Submission to Draft 2026 ISP Consultation

ANU Centre for Energy Systems (Australian National University)

Figure 1. Influence of LT Plan chronology settings on investment decisions in modified 2024 ISP Model: (a) new build pumped hydro energy capacity, and (b) average duration of new build pumped hydro

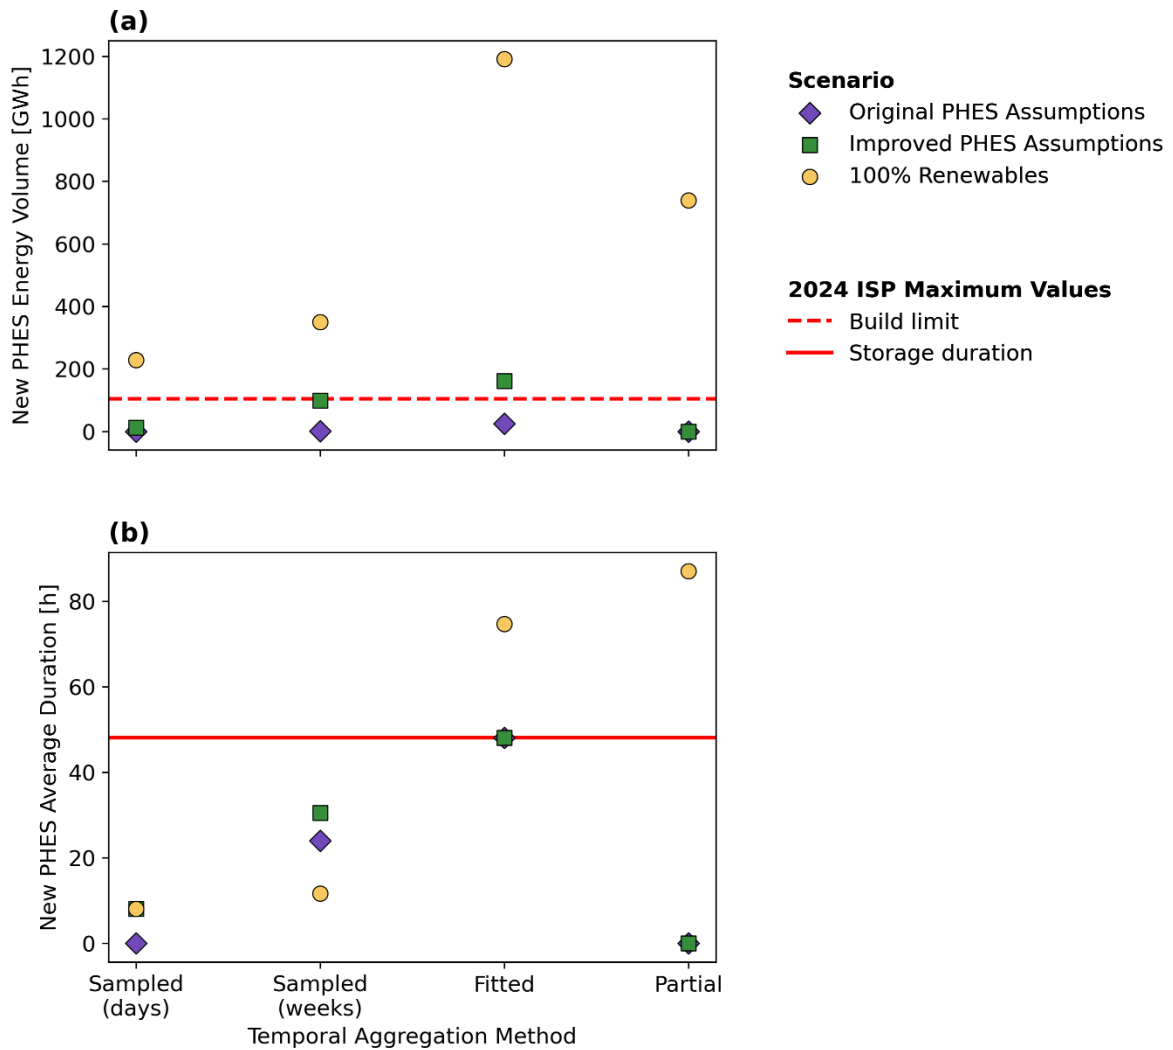
- For the 100% Renewables scenario, the sampled chronology (days) invested in 230 GWh of pumped hydro, while the fitted chronology invested in 1200 GWh of pumped hydro (420% more). This is equivalent to at least tens of billions of dollars in investment dictated entirely by the LT Plan chronology setting. The mere fact that a different chronology setting produces such a large swing demonstrates a serious limitation in the SSLT.

- The sampled chronology is heavily biased towards investing in shorter duration pumped hydro (8- or 24-hour duration), while the fitted chronology invests in long-duration pumped hydro (48- or 160-hour durations). This issue may be the reason why AEMO has previously found no additional value when including pumped hydro options with a storage duration longer than 48 hours.

- The fitted chronology finds a “near-optimal” solution to the 100% Renewables scenario (i.e., close to the cost of the least-cost solution), while the solution using the sampled chronology setting (2 days per month) appears substantially more expensive than the least-cost solution. **Using the sampled chronology setting would give the false impression that a 100% renewable electricity NEM is not cost competitive with a gas-dependent system.**

The sampled chronology in the Single-Stage Long-Term (SSLT) model fails to capture the value of long-duration energy storage and is heavily biased towards gas-powered generators instead. The SSLT should be replaced with a better process that is not affected by this issue.

Figure 2. Net state-of-charge for pumped hydro in 100% Renewables scenario over two-week period for: (a) full-series optimisation (no chronology simplification), (b) Sampled (days), (c) Sampled (weeks), (d) Fitted, and (e) Partial

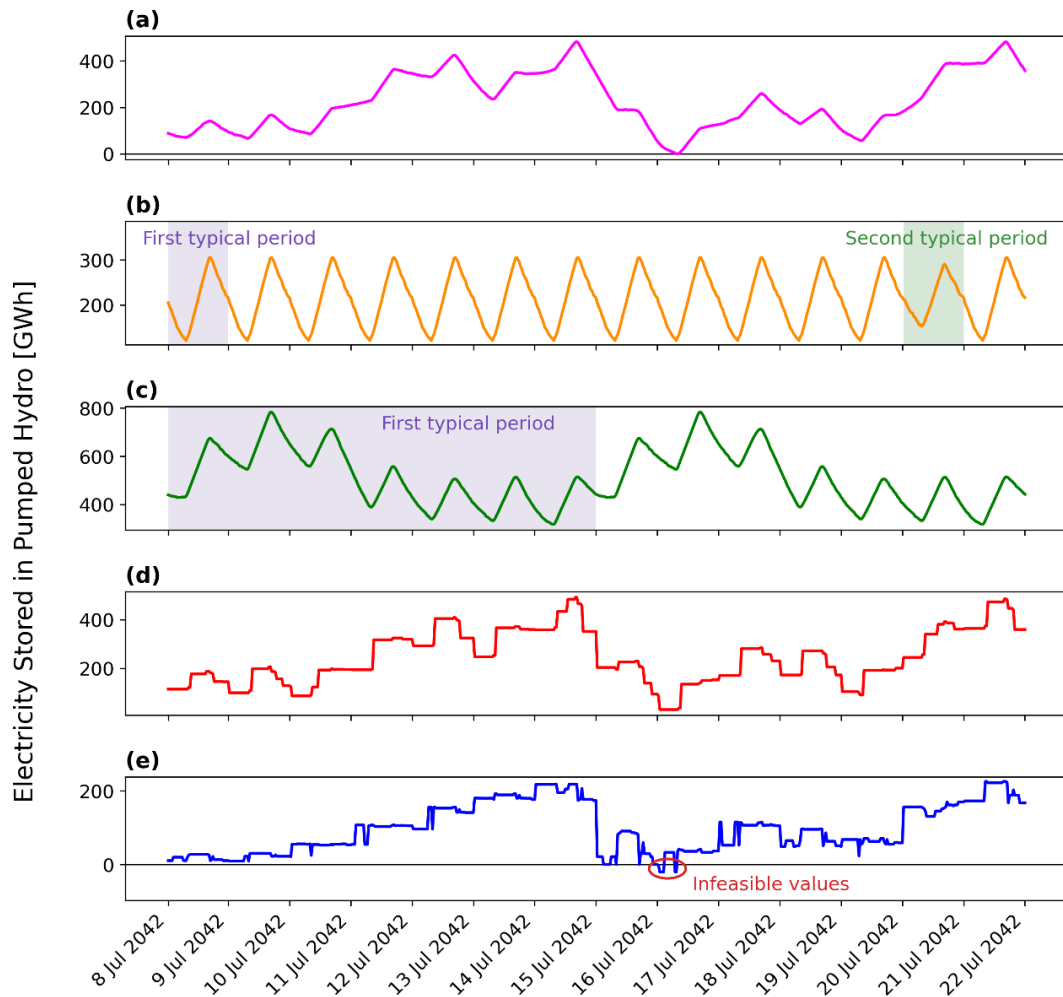
When using the sampled chronology setting, PLEXOS constrains storage state-of-charge to be equal at the start and end of the representative period. This is mathematically necessary for maintaining state-of-charge chronology between representative periods, but prevents cycling for periods that are longer than the representative period. For example, the sampled chronology setting based upon representative days per month prevents storage systems from cycling for periods longer than 1 day. The LT Plan cannot find value in investing in long-duration energy storage since it cannot cycle the system over a long period of time (e.g., weekly or seasonally). This behaviour is depicted in Figure 2.

The state-of-charge profile for the fitted chronology in Figure 2d closely resembles the full-series optimisation (i.e., no time-series aggregation) in Figure 2a. When comparing the investment and dispatch decisions made using each chronology setting, the fitted chronology produces a solution that most closely resembles the full-series optimisation. The sampled chronology produces solutions that are very different from the full-series optimisation (refer to the L1-distance discussion in the pre-print for details).

However, the **SSLT is not fit-for-purpose** when modelling long-duration energy storage or 100% renewable energy systems **due to its usage of the sampled chronology LT Plan setting.** In the absence of long-duration energy storage, the SSLT has no option but to invest in gas-powered generation to manage infrequent solar

Figure 3. Power capacity costs (powerhouse, switchyard, tunnels) and energy capacity costs (dam walls) for pumped hydro options within 50km of the NEM, assuming: (a) 8-hour duration, (b) 24-hour duration, (c) 48-hour duration, and (d) 160-hour duration. Includes an additional 50% overhead cost.

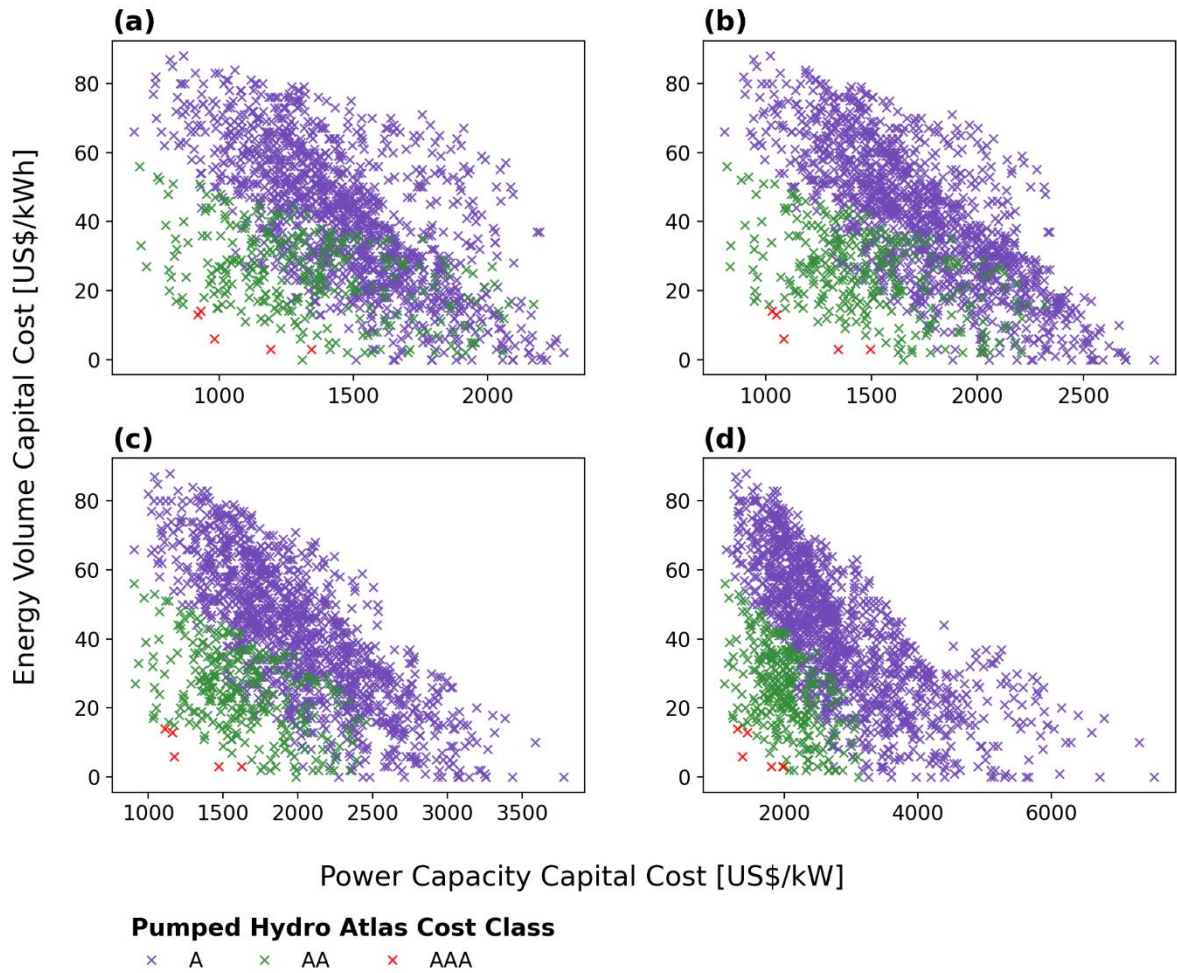
Separate from the anomaly associated with the update to locational cost factors, the existing pumped hydro cost model remains unsuitable for large-scale, long-duration systems. Although Snowy 2.0 costs are currently undergoing a review and are expected to increase, it is still likely to be substantially cheaper per unit of energy volume than any new build sites considered by the *Draft 2026 ISP*. Assuming a rough final cost of A\$15 billion¹³, Snowy 2.0 has a capital cost of A\$43/kWh compared to the A\$163/kWh for 48-hour pumped hydro (the longest duration in the *Draft 2026 ISP*) in *GenCost 2024-25*¹⁴ with locational cost factors ranging between 0.9407 to 1.1567¹⁵. Building deep energy storage in the *Draft 2026 ISP* is four times more expensive than Snowy 2.0, whereas there are many mainland sites near transmission that match Snowy 2.0 for cost.

Part of this issue appears to relate to the underlying cost model, which ought to be reviewed to develop appropriate costs for the **best quality large-scale long-duration** pumped hydro systems near the NEM (similar in scope to Snowy 2.0), rather than small-scale high-power systems. Developers will prefer to develop the highest quality, lowest cost options available, so an average cost representing all possible sites in a subregion is not suitable. A bottom-up cost model (similar to the National Laboratory of the Rockies pumped hydro cost model developed for the United States of America¹⁶) could be applied to a selection of the best quality pumped hydro options near the NEM (based on the latest version of the Atlases).

We filtered the Atlases for all class A, AA, and AAA pumped hydro systems near the existing NEM transmission network which are outside protected areas and large urban centres.¹⁷ The parametric cost model used by the ANU to generate cost classes for the Atlases was applied to each of the sites, with an added 50% overhead.¹⁸ Power capacity costs (\$/kW) and energy volume costs (\$/kWh) for each site were estimated, assuming they could be an 8-, 24-, 48-, or 160-hour duration system. These cost estimates are summarised in Figure 3. The intention of this figure is not to provide an exact estimate of the cost for each project, but to demonstrate the relative difference in costs between different storage durations and cost classes. Furthermore, none of the pumped hydro sites in this list have been subject to geological, hydrological, environmental, heritage, community impact and other studies. As with all major engineering

The cost model for pumped hydro is not representative of high-quality, large-scale, long-duration off-river systems and should be updated. A bottom-up cost model should be applied to the best quality pumped hydro options near the NEM transmission network (including transmission augmentation options) to recalculate the \$/kW CAPEX for each storage duration.

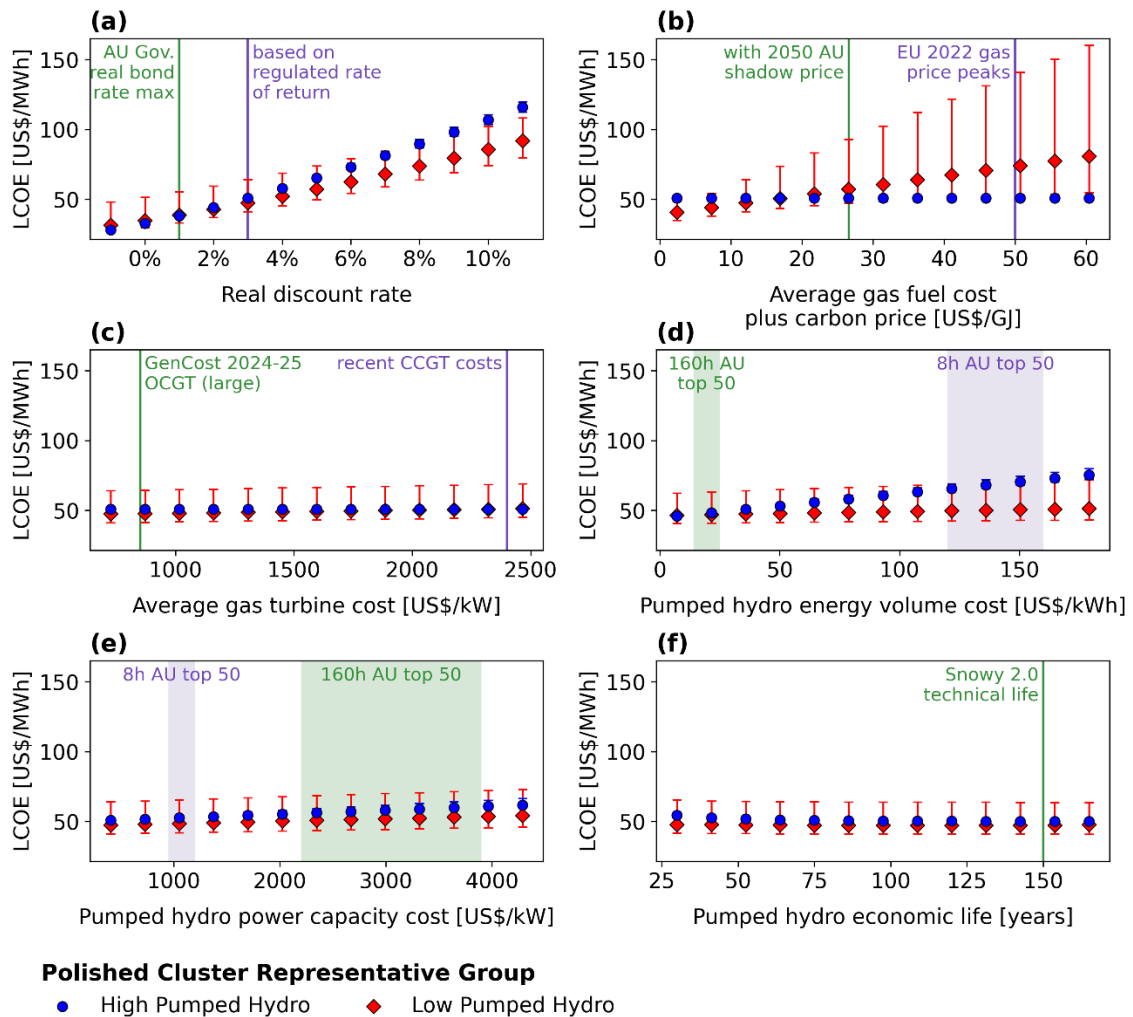
We modelled a sample of near-optimal NEM grid configurations using PLEXOS and performed a one-at-a-time sensitivity analysis for their all-in system costs (refer to pre-print for additional details). Half of these grid configurations were 100% renewable systems (“High Pumped Hydro”) and half were gas-dependent systems (“Low Pumped Hydro”). All-in system costs were expressed as a levelised cost of electricity (LCOE) for the entire system. Results of the sensitivity analysis are shown in Figure 4.

For a large range of parameters around the baseline, the 100% renewable electricity and gas-dependent NEM configurations have roughly the same cost. The 100% renewables configurations are more sensitive to the discount rate than the gas-dependent systems, meaning that over-estimating the real WACC/discount rate can heavily penalise fully decarbonised development paths (Figure 4a). Configurations that are more dependent upon gas generation can become substantially more expensive than the 100% renewable configurations at a high gas cost (Figure 4b). The all-in LCOE is also reasonably sensitive to the energy volume cost of pumped hydro, with the best long-duration (e.g., 160-hour) sites offering a much smaller \$/kWh energy volume cost than the best short-duration (e.g., 8-hour) sites (Figure 4d). This reinforces the notion that pumped hydro cost assumptions in the ISP should reflect the best quality large-scale long-duration pumped hydro sites. Note that for higher baseline discount rates, the LCOE becomes more sensitive to the pumped hydro economic life.

A small number of large-scale, long-duration pumped hydro systems would perform a unique role in energy security and are expected to act as a natural monopoly. Large-scale, long-duration pumped hydro should have a long economic lifetime (~75 years) and a real WACC similar to other natural monopolies, such as transmission. The 40-year economic lifetime and 8.5% real WACC used for the Step Change scenario in the *Draft 2026 ISP* is not suitable for large-scale long-duration pumped hydro systems (equivalent to the scale of Snowy 2.0). Furthermore, corporate government entities such as Snowy Hydro, Queensland Hydro, and Hydro Tasmania have access to much cheaper capital.
